File FPP-1996-052

Name: South Rim – Filing 5 – NE of Filing #1/N of Filing #3

SOUTH RIM SUBDIVISION, FILING NO. FIVE

Re: Response to review comments, South Rim Filing No. Five, File #FPP-96-52, Job #95150.40.

**WATER AND SANITARY SEWER
PLAN & PROFILE**

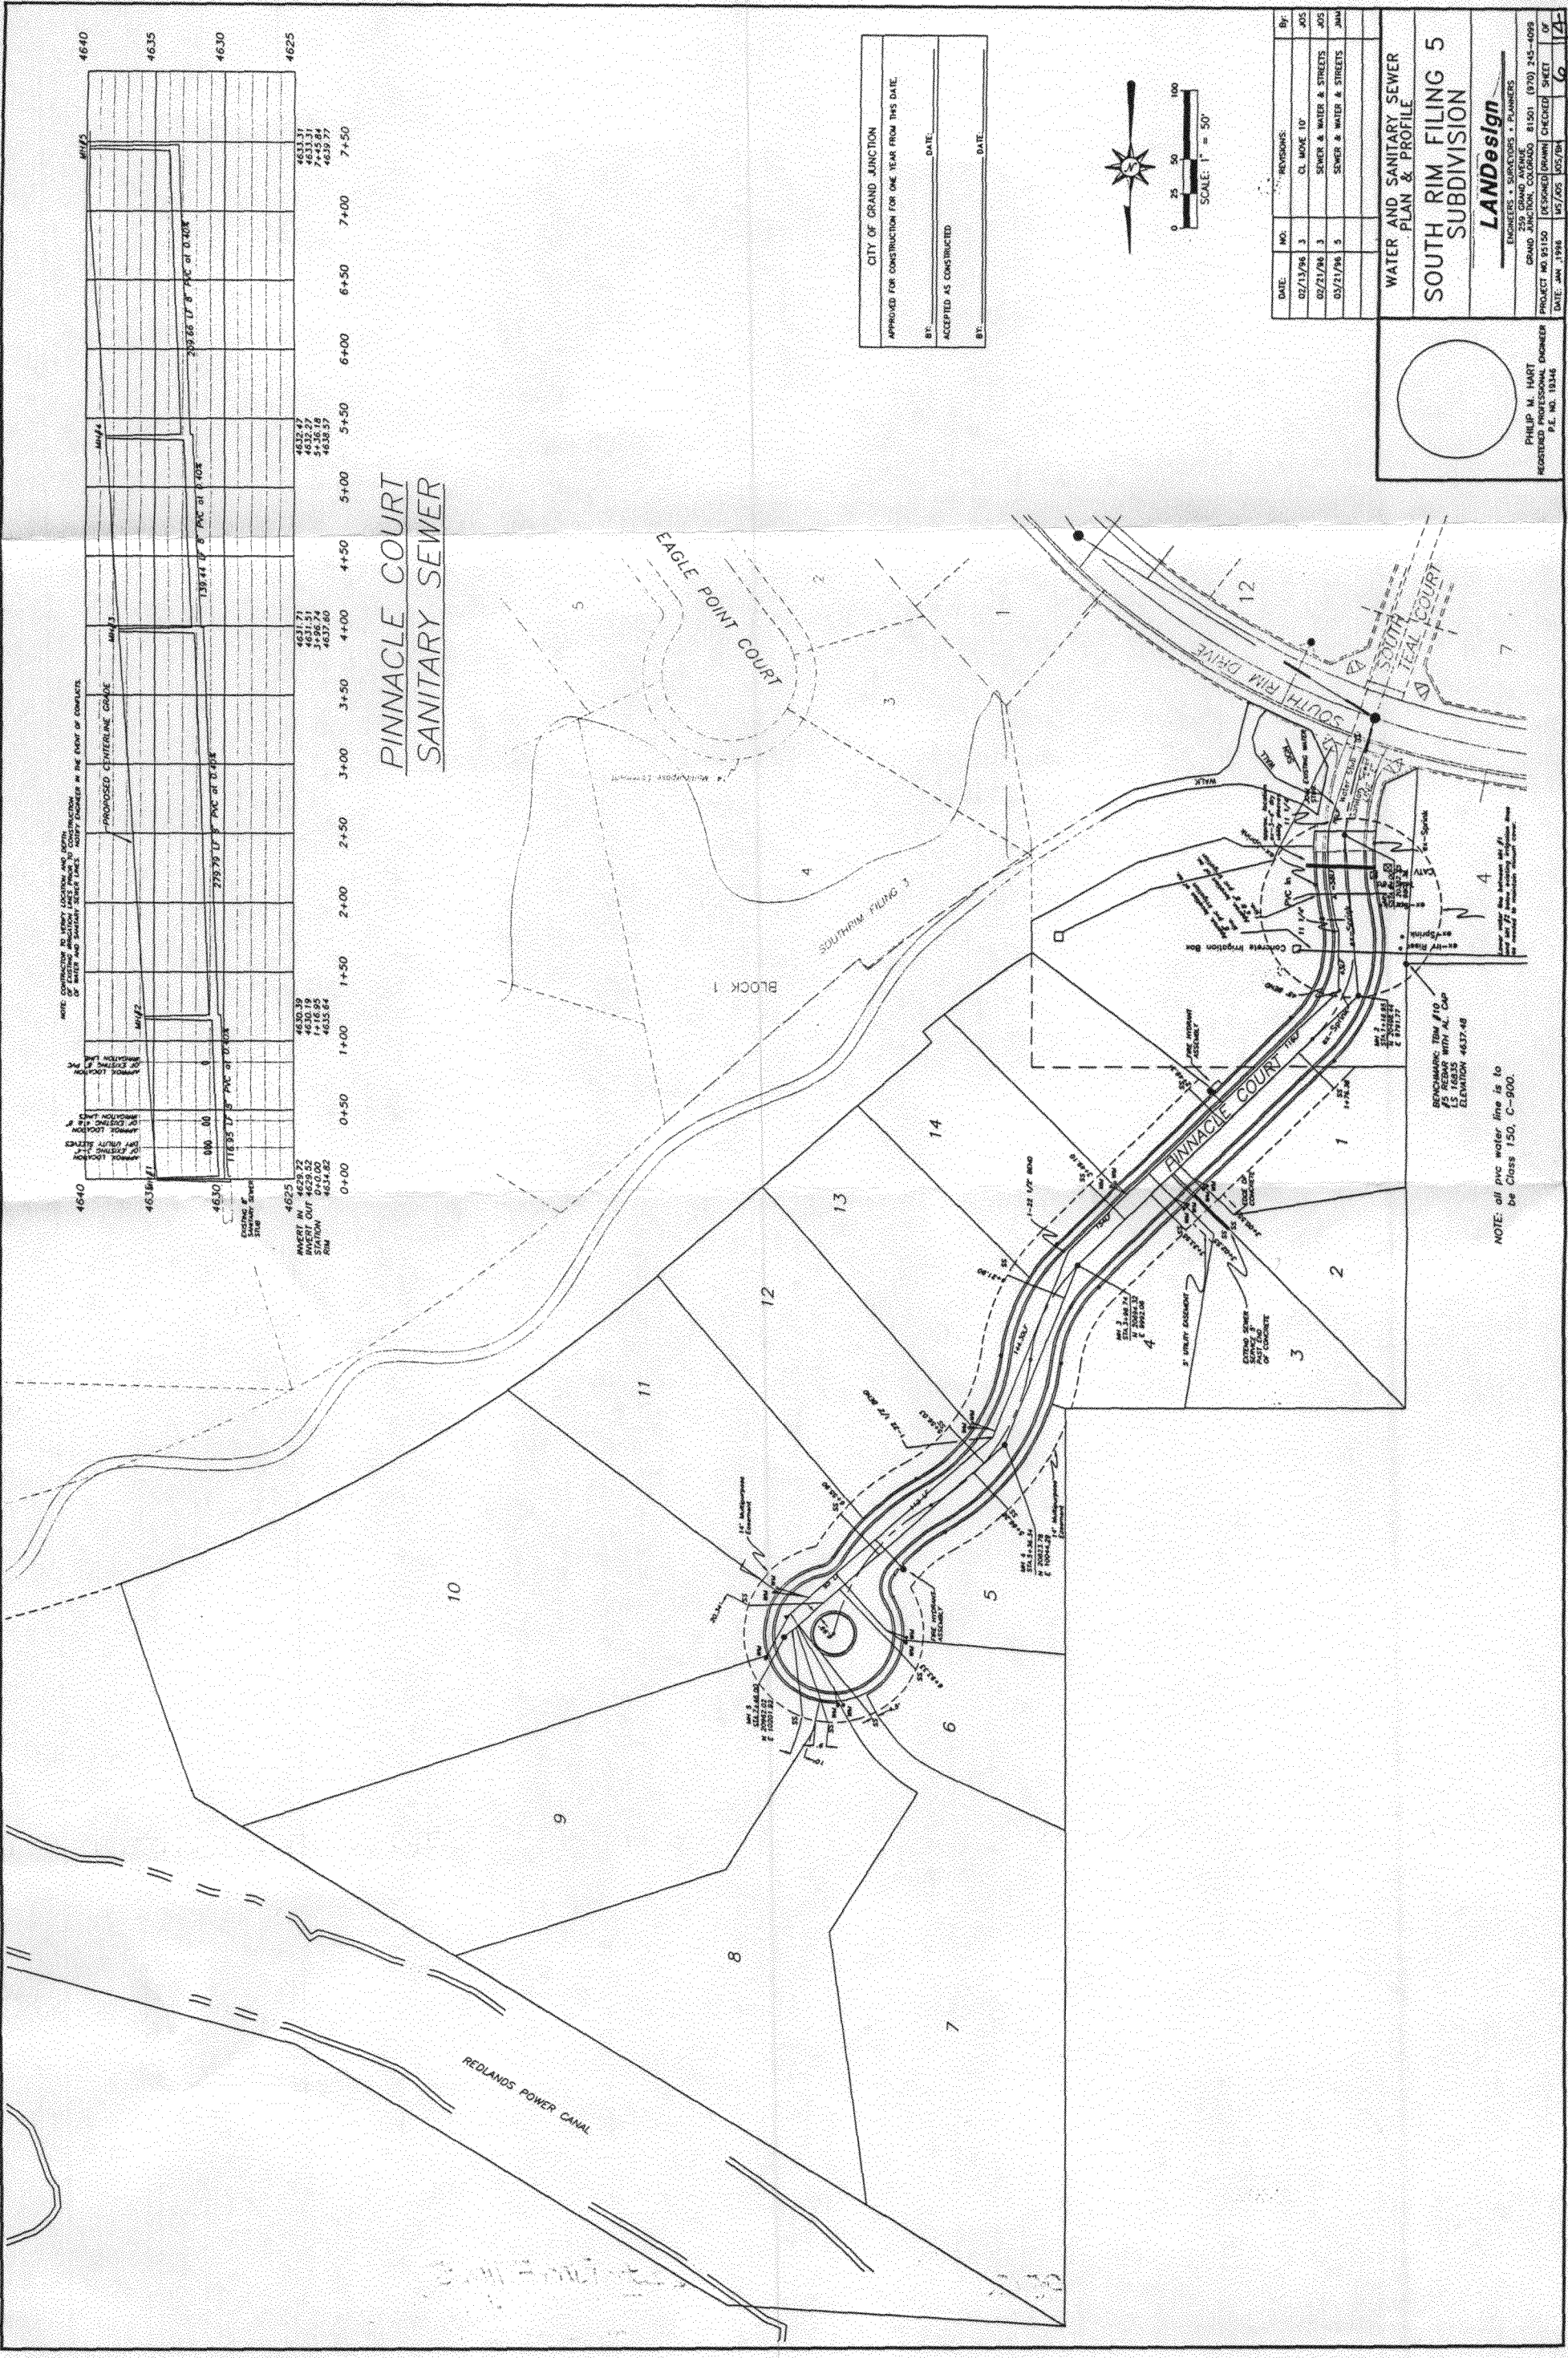
1. Professional Engineer's signature is a stamp. This is a violation of the Colorado State Board of Registration for Professional Engineers and Professional Land Surveyors. State Board will be notified if this practice is continued.
2. Sewer is too close to Outlot B which is dedicated to homeowner association. Sewer needs to be a minimum of 10' away from Outlot B in order to provide space for maintenance of sewer line.
3. Please reconfigure water and sewer service lines to lots 5 and 6 so they don't cross.

1. This comment is acknowledged.
2. The sanitary sewer alignment has been revised to provide a maximum clearance between the line and "Outlot B". This revision has been presented to the City Utility Engineer and has been verbally approved.
3. The sanitary sewer and water services to lots 5 and 6 have been revised in accordance with this comment.

GRADING & DRAINAGE PLAN
 SOUTH RIM FILING 5
 SUBDIVISION

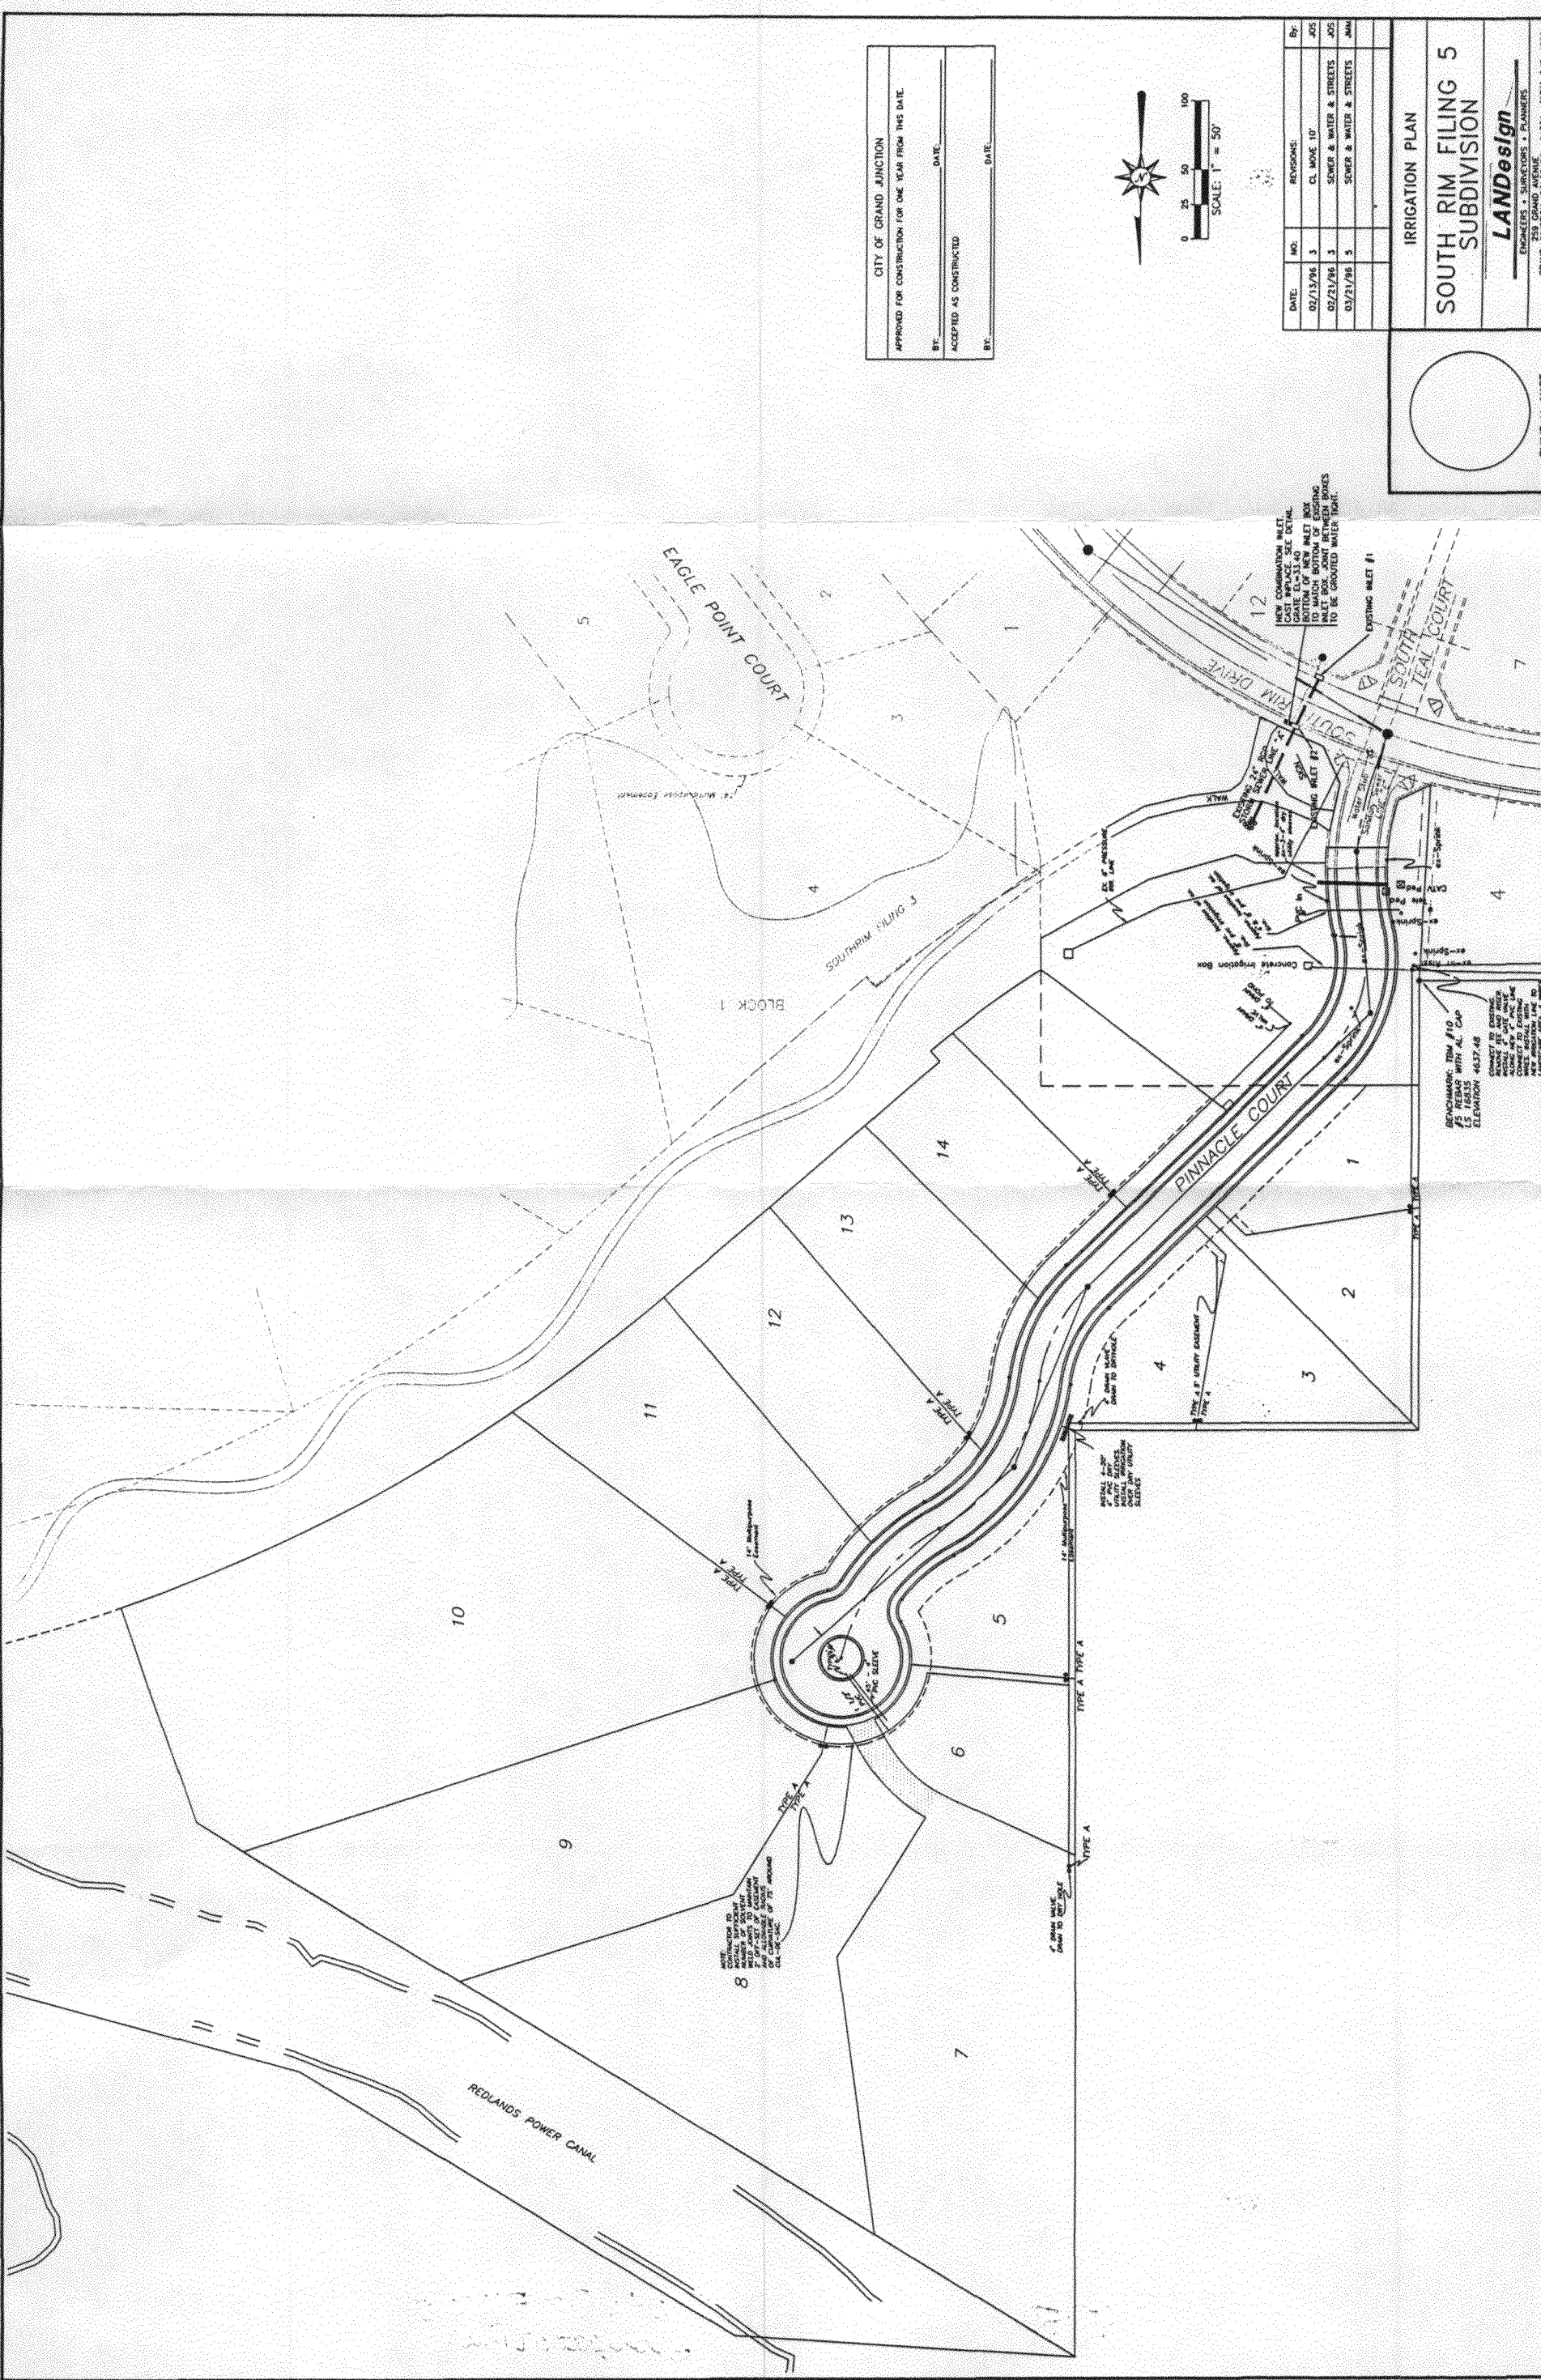
1. Cul-de-sac pavement width shall be 28 feet. There is no need for one-way signing.
2. Please locate all existing improvements (e.g. trail, landscape planter) on Grading and Drainage Plan.

2. The existing improvements at the intersection of Pinnacle Court and South Rim Drive have been added to all construction drawings.
